ECE/TRANS/WP.29/GRSG/2008/4/Rev.3
10 August 2009

REGULATION No. 116
(Protection of motor vehicles against unauthorized use)

Revised proposal for draft amendments to Regulation No. 116

Submitted by the expert from Japan */

Paragraph 6.4.2.1.

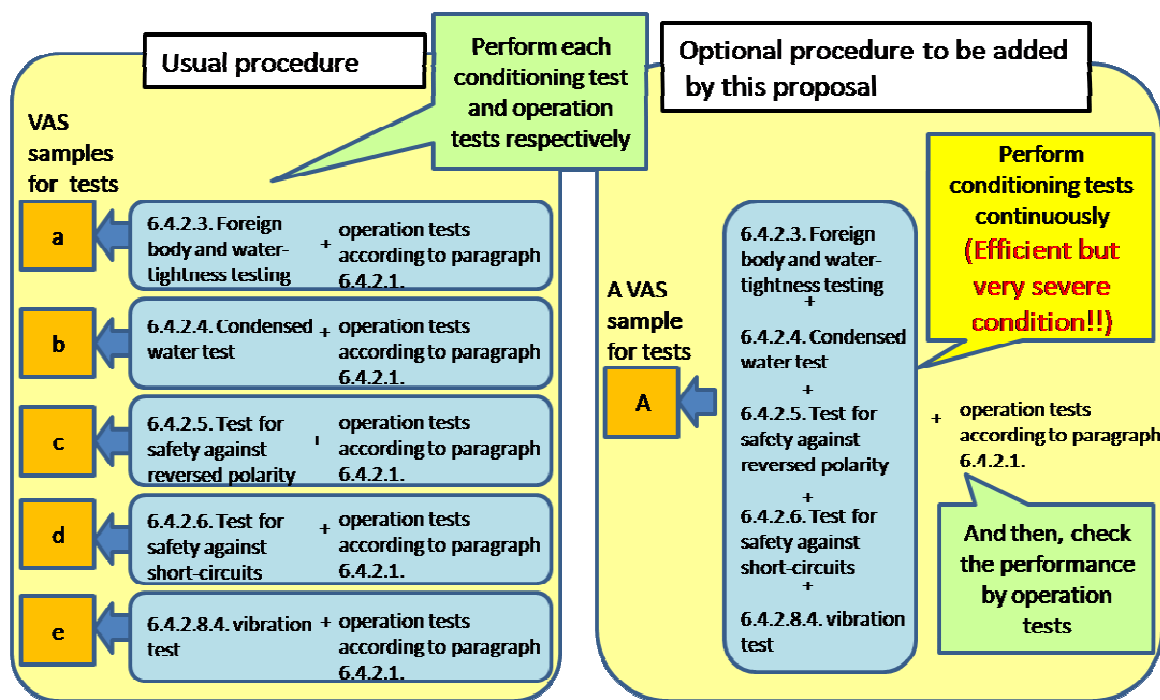
- "6.4.2.1. Operation tests
- For the operation tests required according to paragraphs 6.4.2.3., 6.4.2.4., 6.4.2.5., 6.4.2.6. and 6.4.2.8.4., if some of the tests required in each of these**

paragraphs prior to the operation tests are performed in series on a single VAS, the operation test may be carried out one time only after the chosen tests are completed instead of performing the operation tests required in the paragraphs after each of the chosen tests. "

This proposal is to add an optional procedure for this Regulation to streamline the operation tests repeatedly required according to paragraphs 6.4.2.3., 6.4.2.4., 6.4.2.5., 6.4.2.6. and 6.4.2.8.4. by adopting more rigorous conditions.

Performing some of the tests required in these paragraphs prior to the operation tests in series for a sample is more rigorous than performing one of these tests before performing the operation test with regard to test conditions.

According to this amendment, manufacturers can choose this option to decrease their work for obtaining type approval, provided they have sufficient quality for a VAS to do so.
